Report of two site surveys carried out 26th and 27th September 2011.

1.8) Entrance onto path across fields onto Busway.

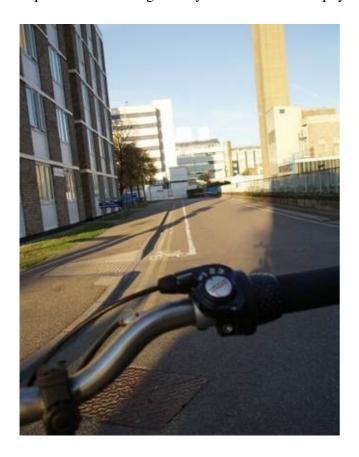
Although we accept this is a temporary arrangement, it is not clear as to the time span of the final route onto the Campus. As it is used by many cycle commuters from Trumpington, the lack of a proper flush kerb, or even a dropped kerb is a serious impediment to easy or safe access.

Solution: Short term modifications to generate flush kerbs and signage on the roadway to indicate that a cycle route is joining/crossing the road.

4.4) Alternative locations for parking.

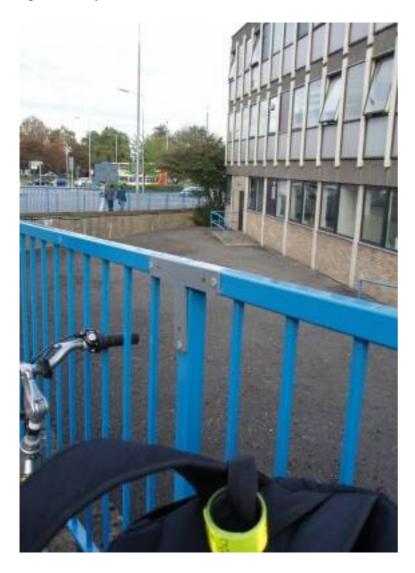
Would employees, especially ones who work full-time, be prepared to walk slightly further (250 yards rather than 20-50 yards to entrance) to use secure staff card access only, covered, decently spaced cycle parking? Thus freeing less secure open access parking nearer the entrances for visitors.
